## ARCHITECTURAL REVIEW COMMITTEE MEMORANDUM

SUBJECT: STACK FAMILY TRUST, OWNER FOR A MAJOR ARCHITECTURAL REVIEW APPLICATION FOR THE CONSTRUCTION OF A 4,122-SQUARE FOOT SINGLE-FAMILY HOUSE ON A HILLSIDE LOT LOCATED AT 2368 CITY VIEW DRIVE, ZONE ESA-SP PLANNING AREA, LOT 53, DESERT PALISADES SPECIFIC PLAN, SECTION 3 (CASE 3.4299 MAJ). (GM)

FROM: Development Services Department – Planning Division

SHEET  
**L-1.0**

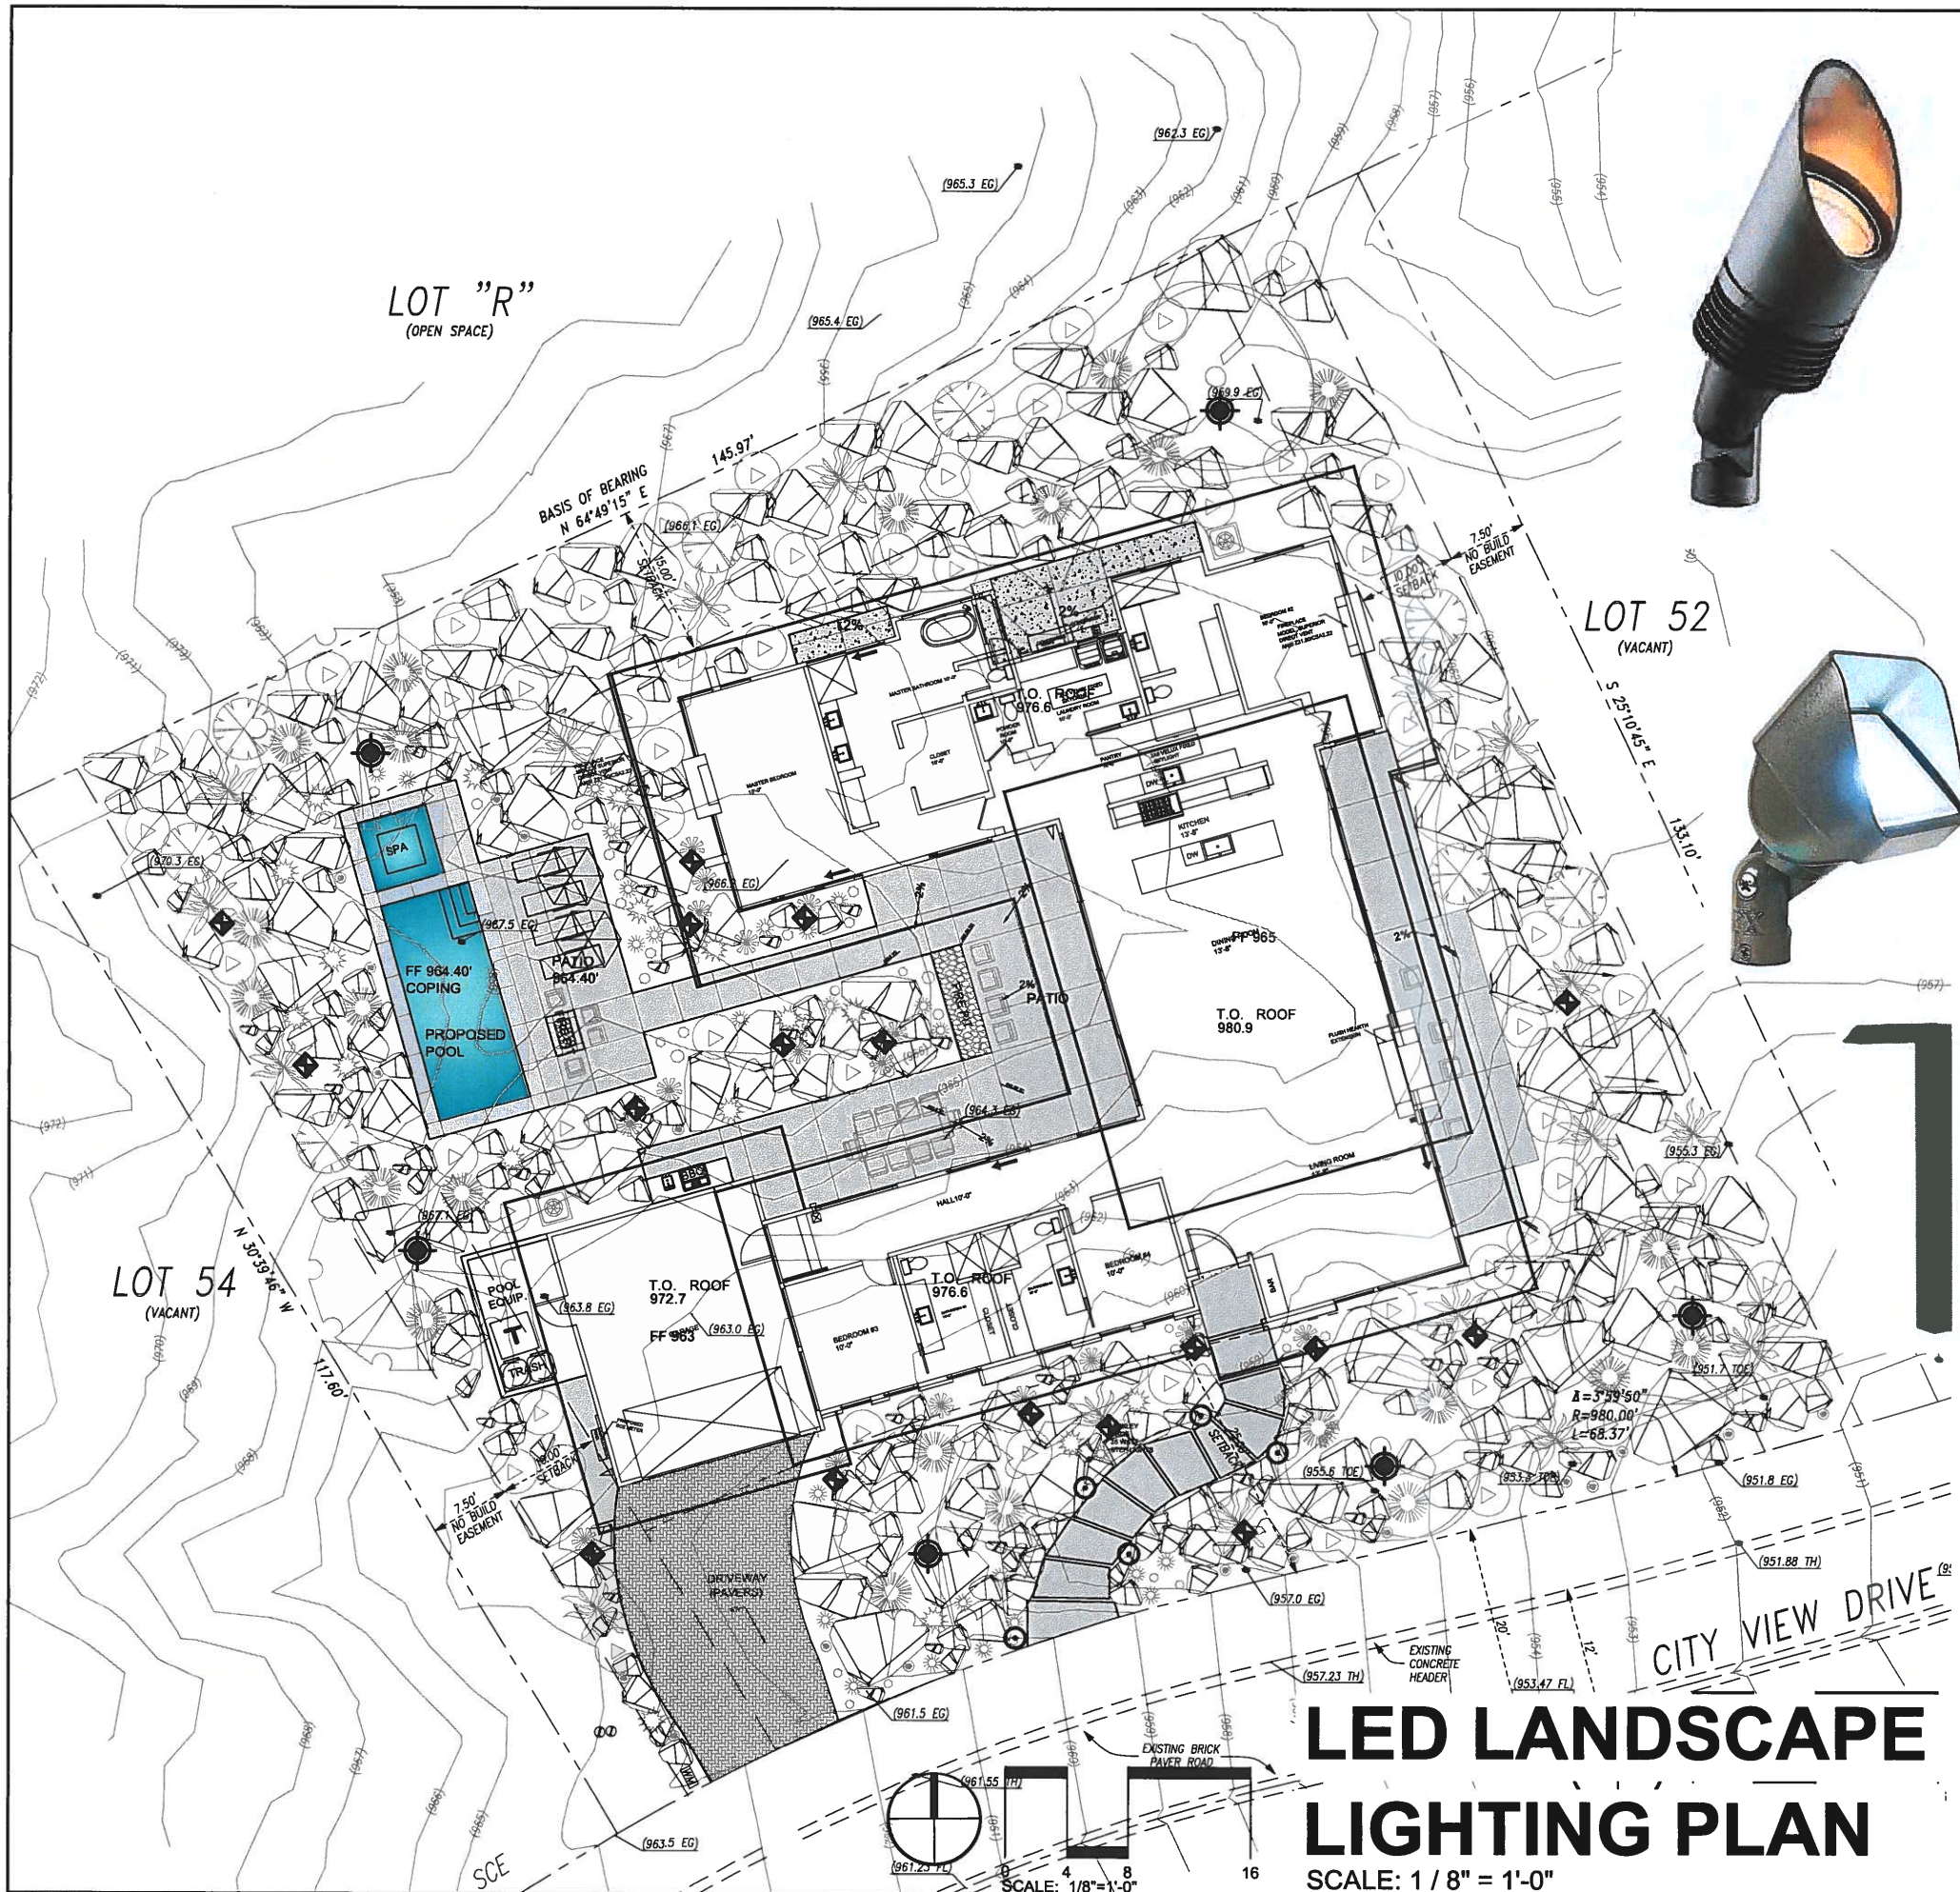
2. Landscape plan showing locations of plants, sizes, and quantities.  
*Revision: The landscape plans have been revised showing greater detail with placement of boulders and rocks. A new dense 36" to 48" Desert Ironwood tree has been added at the driveway to screen the front facing garage. Other trees have been slightly moved to open views from the interior.*

Member Doczi pointed out there are several boulders on the plans which need to be shown on the grading plan; and questioned the number of up-lights. Mr. Stack provided details about their intent for the lighting plan.

- Landscape plan showing locations of plants, sizes, and quantities.
- Landscape plans have been revised
- Driveway to be off set and allow a plant grouping to soften the garage door.

Section A-A Profile

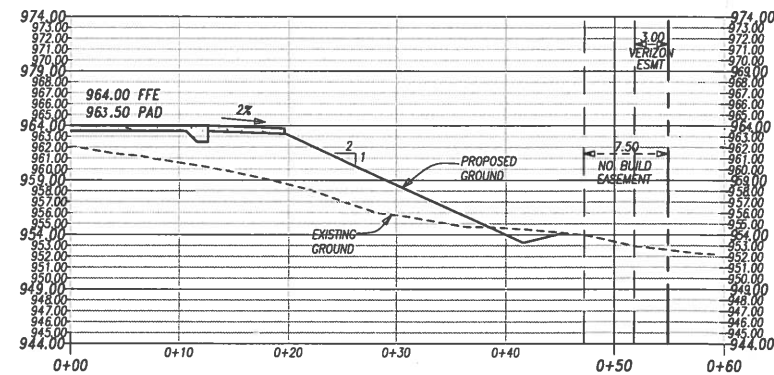
1. Grading plan to reflect slopes and placement of boulder walls and transition grade changes. The ARC was concerned with the slope change on the east side of the house and the transition from the deck off the great room, the exposure of the foundation, and the use of railings.  
*Revision: Cross sections have been added on page G2. It is the intent that a cable railing system would be used if needed. This will allow for a simple barrier that will not be highly visible. A revised landscape plan demonstrates boulder placement on the east side of the house.*

4. Provide several site sections for grade changes.  
*Revision: Cross sections have been added on page G2 and A6.*

Member Poehlein pointed out the terrain variation is between 6 -7 feet from one side of the house to the other and requested a section be provided to show the overall transition.

- Grading plan to reflect slopes and placement of boulder walls and transition grade changes.
- Cross sections have been added on page G2. New Landscape Plan also demonstrates boulder placement

- Revised driveway from straight to curved per AC recommendations
- Provide several site sections for grade changes.
- Cross sections have been added on page G2 and A6
